# UNITED STATES PATENT AND TRADEMARK OFFICE

APPLICATION NO.	FILING DATE	FIRST NAMED INVENTOR	ATTORNEY DOCKET NO.	CONFIRMATION NO.
10/718,501	11/19/2003	Jishnu Bhattacharjee	M-15260 US	8235

<b>Office Action Summary</b>	<b>Application No.</b>	<b>Applicant(s)</b>	
	10/718,501	BHATTACHARJEE ET AL.	
	<b>Examiner</b>	<b>Art Unit</b>	
	Eugene Lee	2815

## DETAILED ACTION

FIG. 11

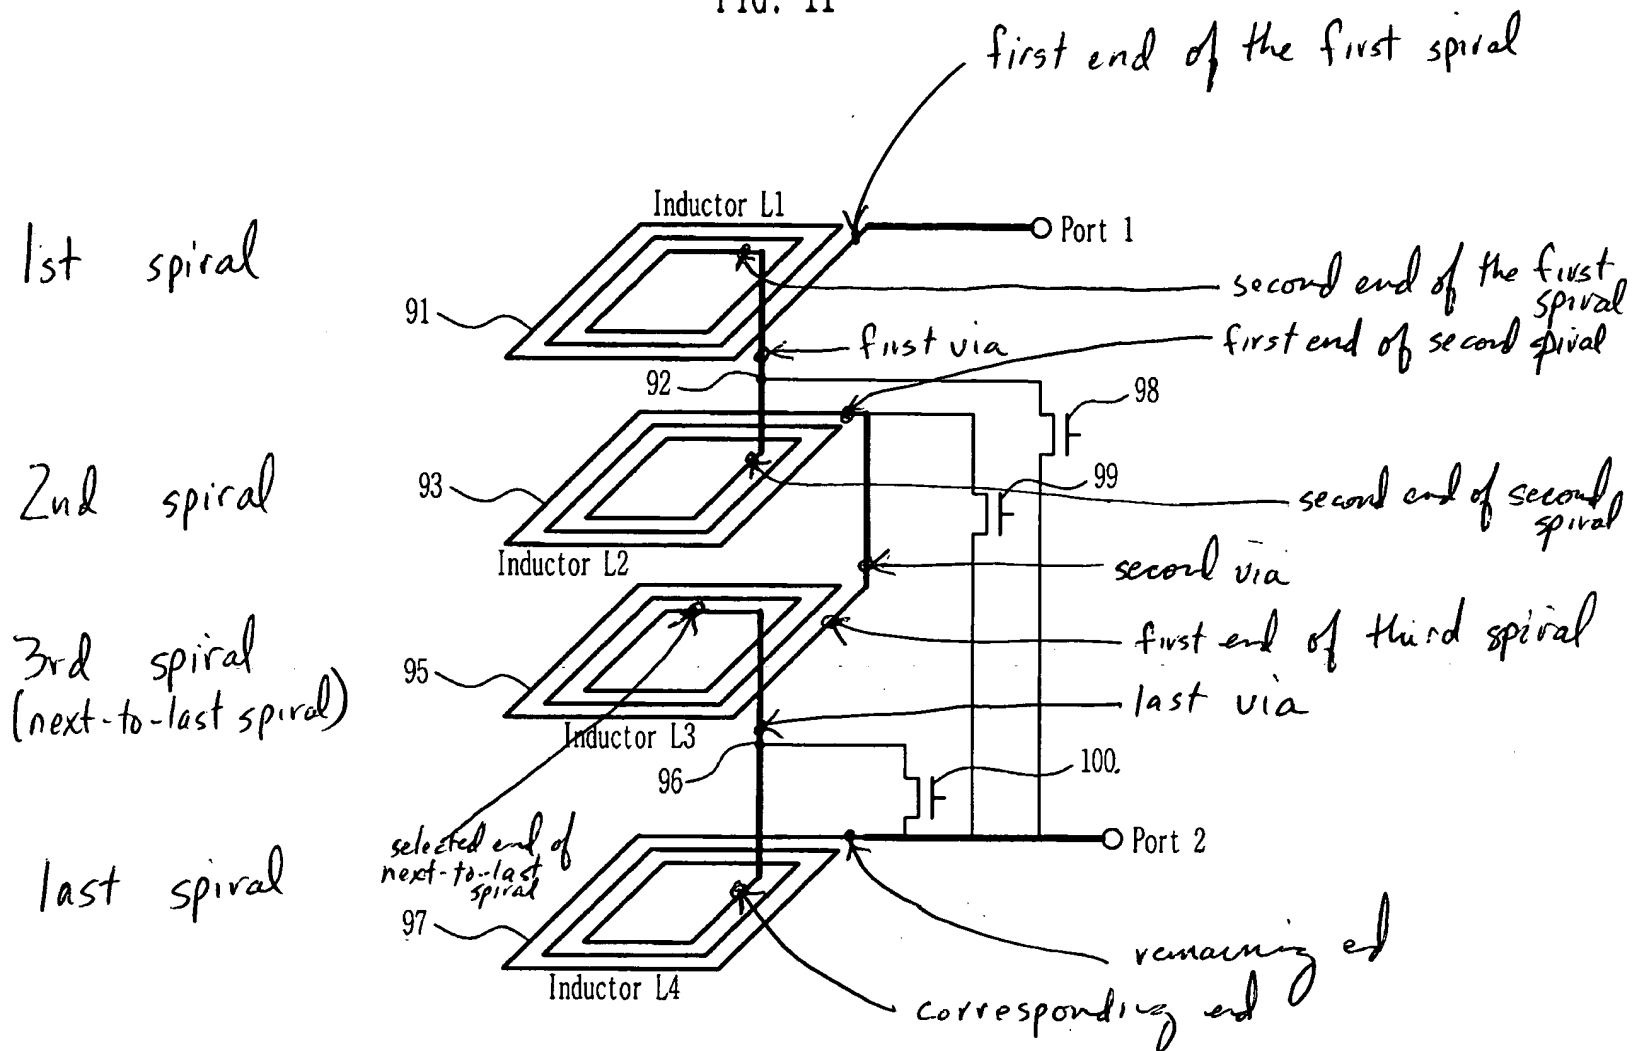
5. In view of the 112 rejection above, claims 6, 17, and 18 are rejected under 35 U.S.C. 102(e) as being anticipated by Kim et al. 6,992,366 B2. Kim discloses (see, for example, FIG. 11, and FIG. 5) a stacked variable inductor (stacked inductor) comprising a semiconductor substrate (see abstract), inductors (plurality of conductive layers/plurality of conductive spirals) L1, L2, L3, L4; and contact electrodes (vias).
